CALCULATED: BRO: CHECKED: PSB: TYPICAL SECTIONS MED - 3 - 09 . 04 5/80

CALCULATED MJB CHECKED PSB	PAVEMENT SUBSUMMARY	MED - 3 - 09 . 04
-------------------------------------	---------------------	-------------------

ROUNDABOUT INTERSECTION DETAIL

ROUNDABOUT
SPLITTER ISLAND DETAIL

ITEM 609 - CURB TYPE 3-B, AS PER PLAN

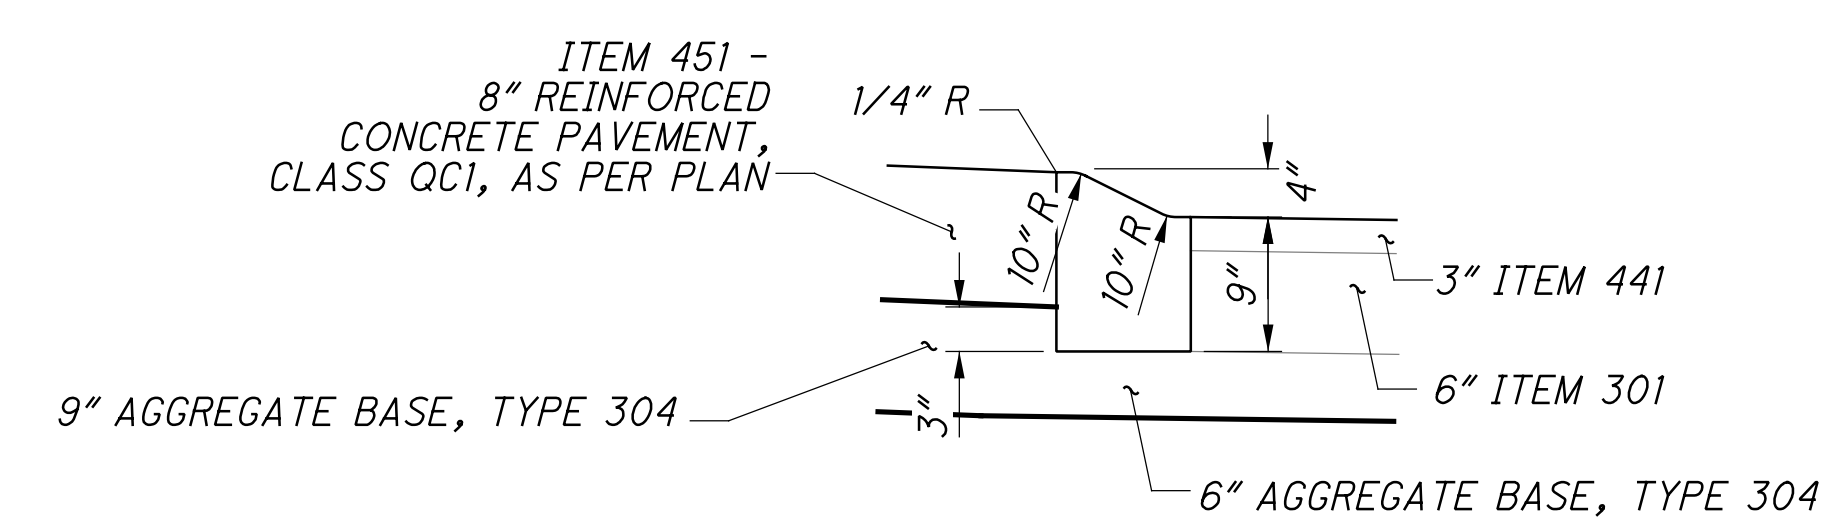
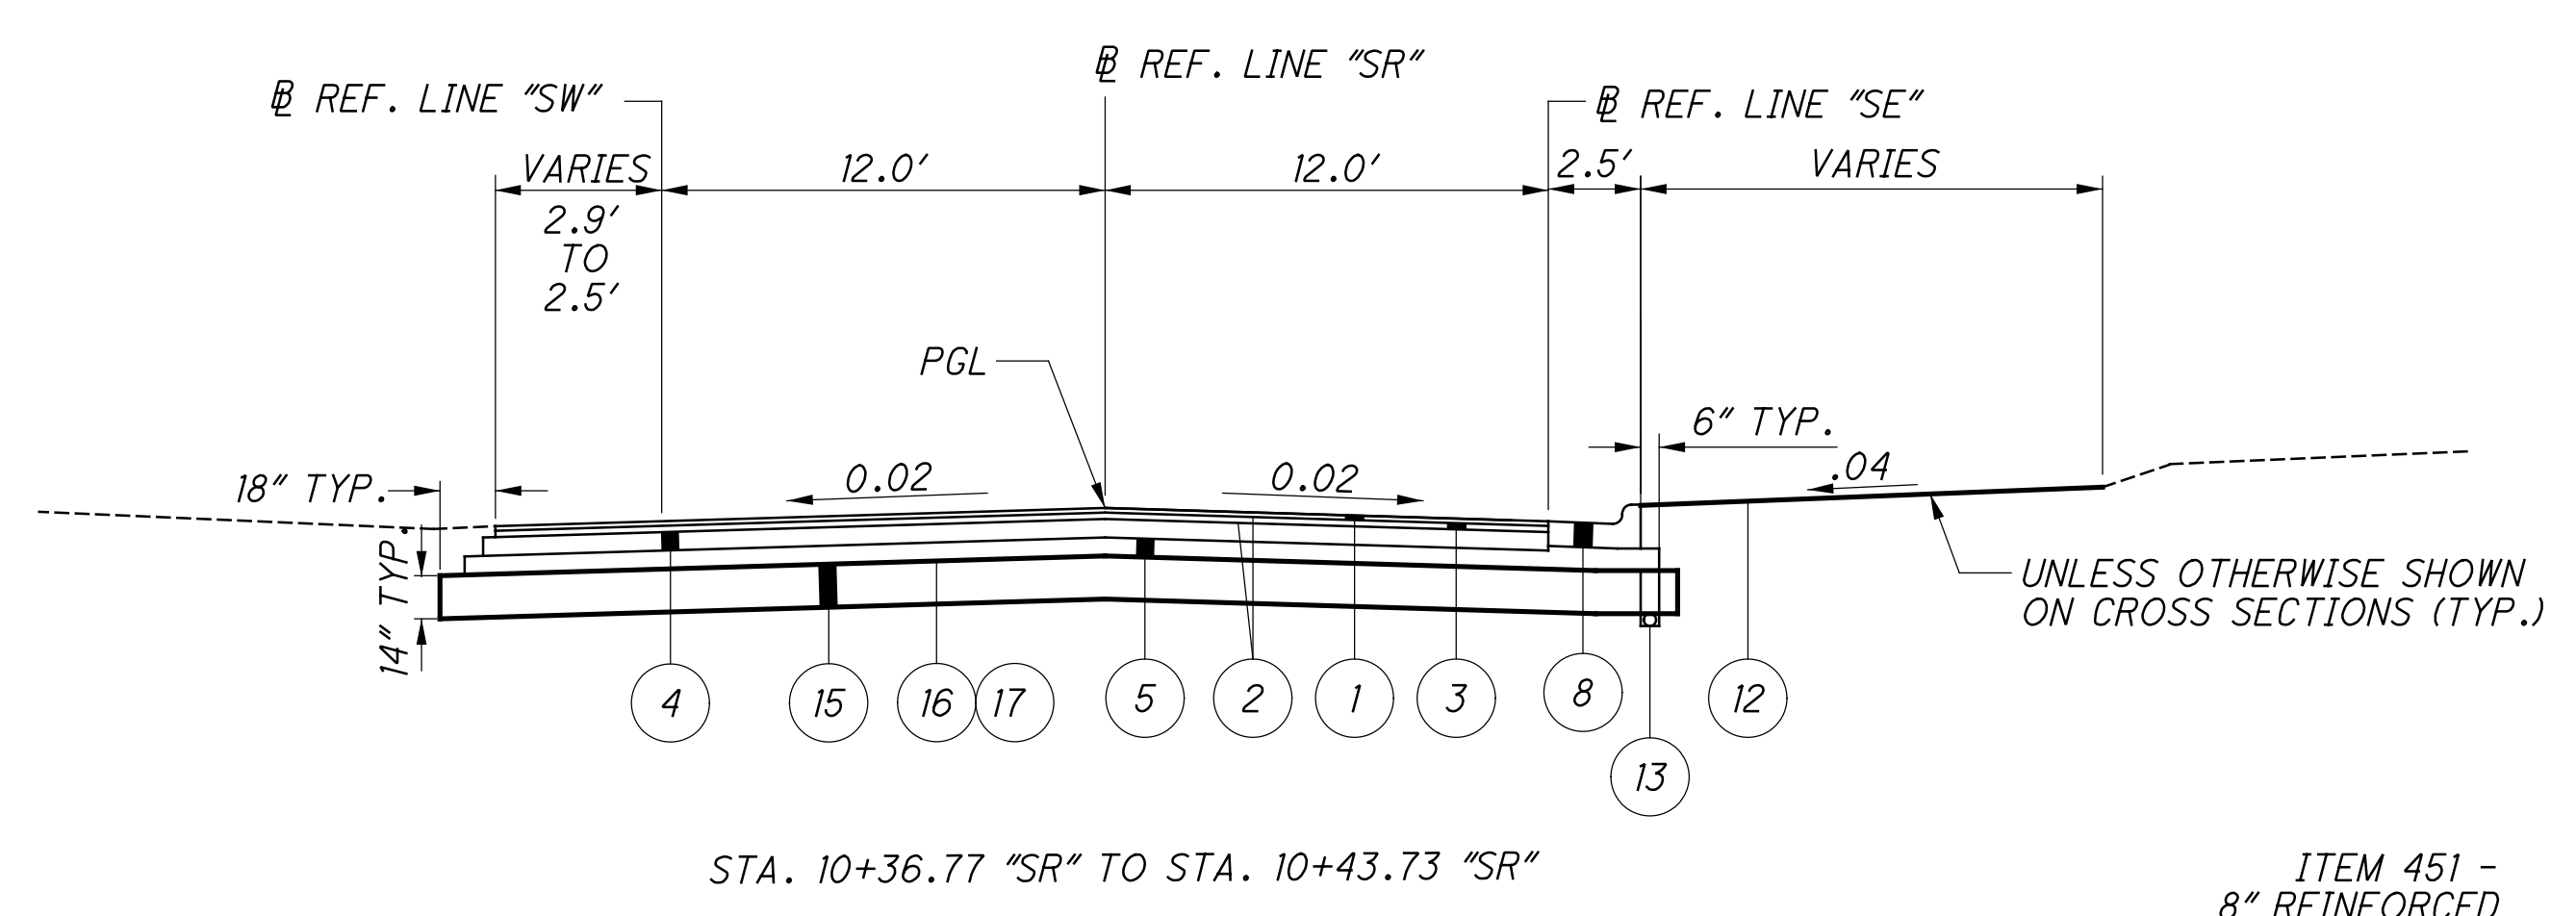
REVISD TO "AS PER PLAN"

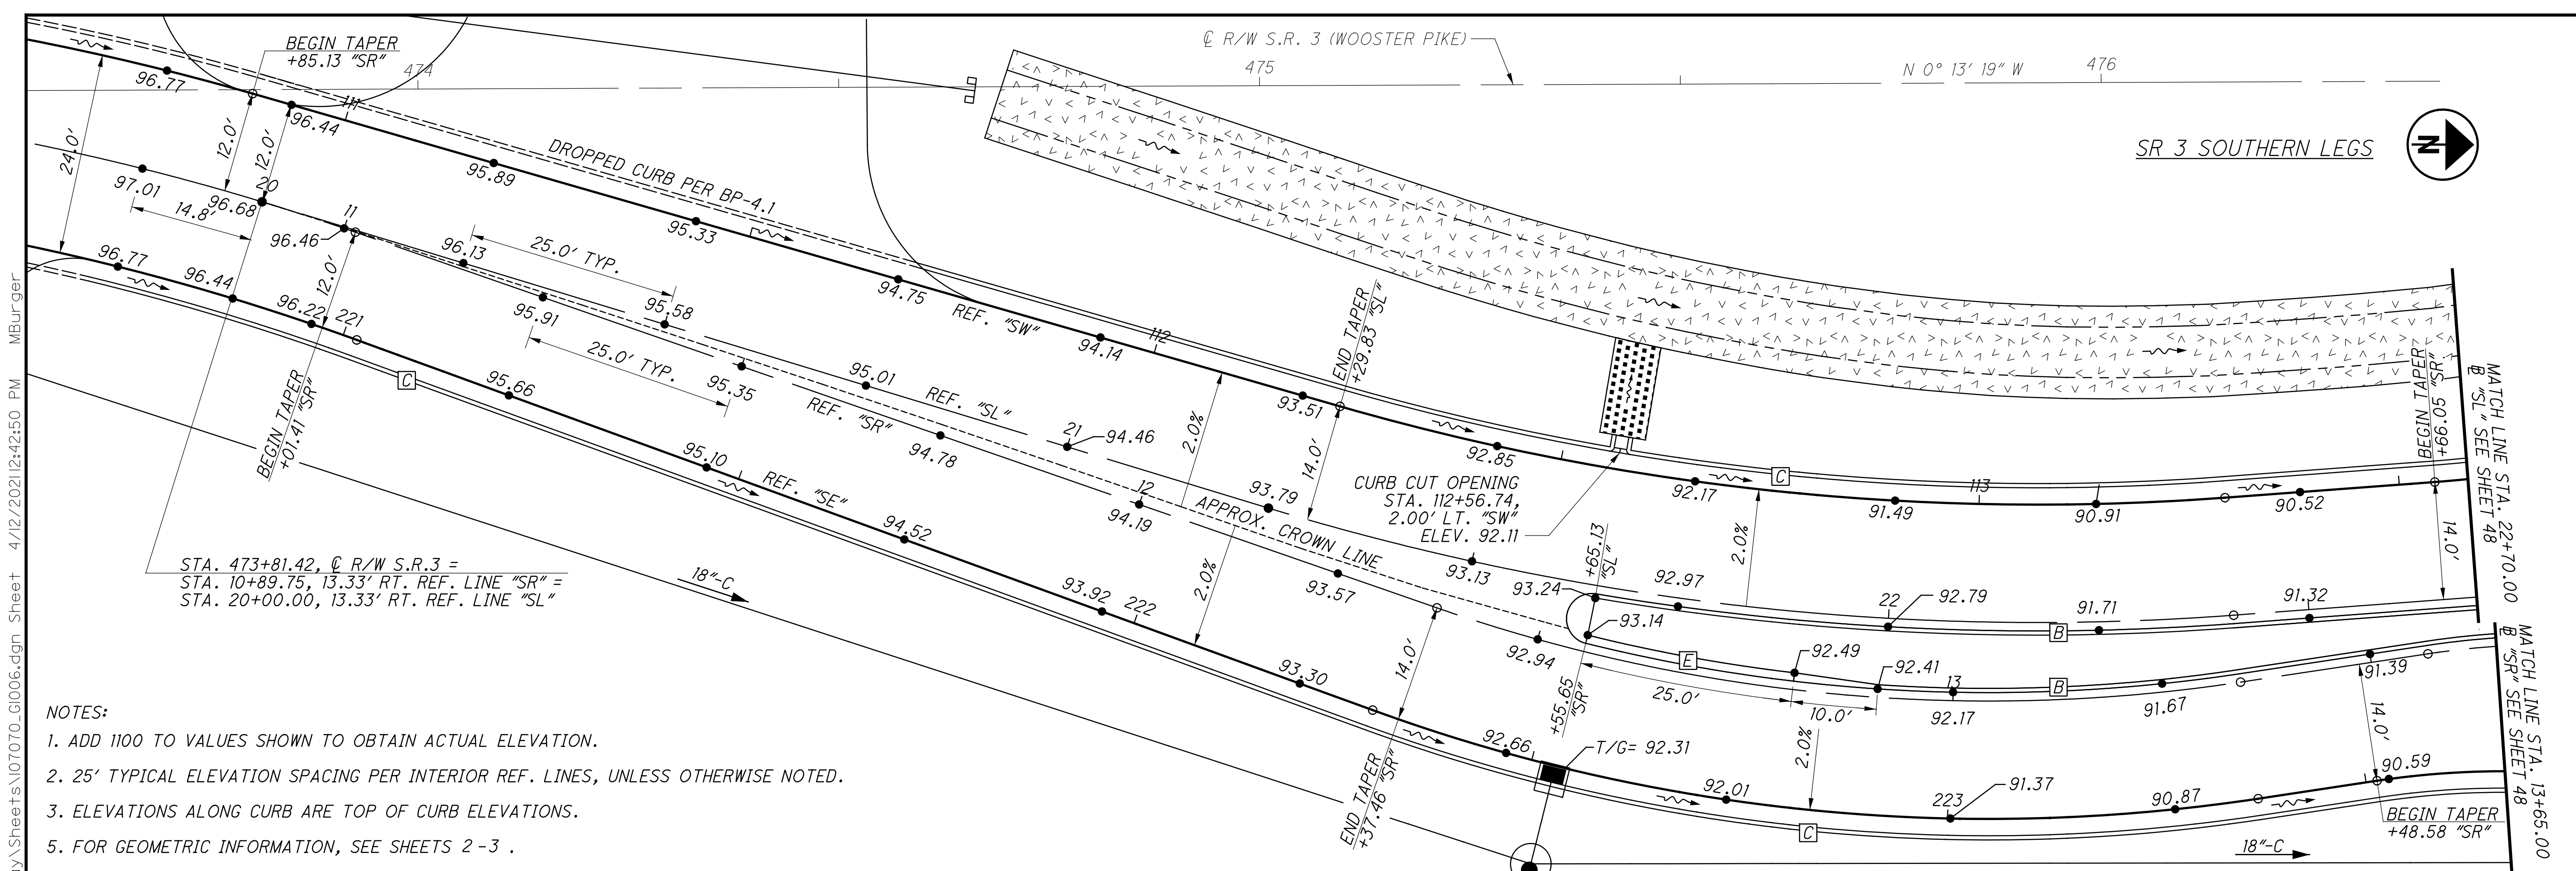
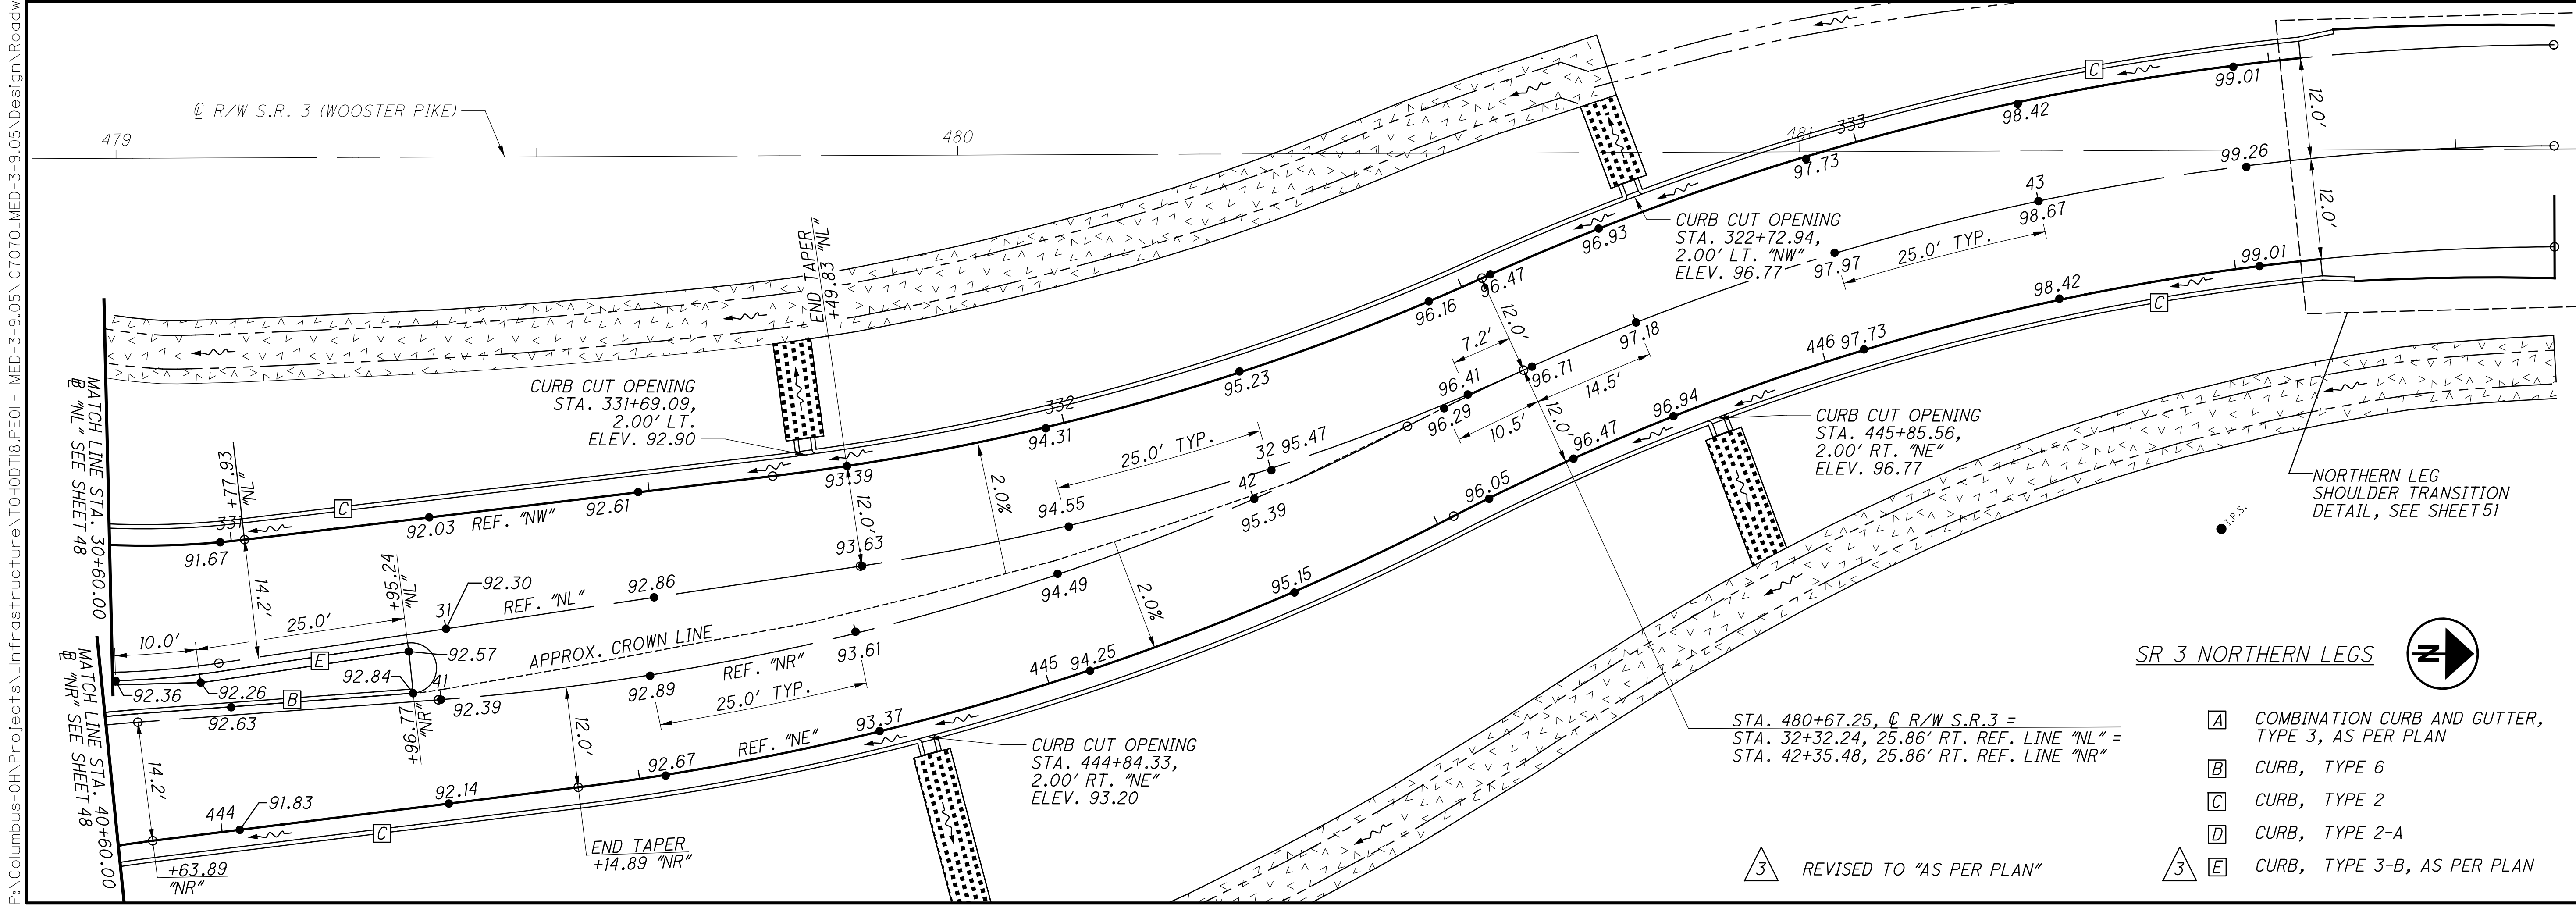
3 REVISED TO "AS PER PLAN"
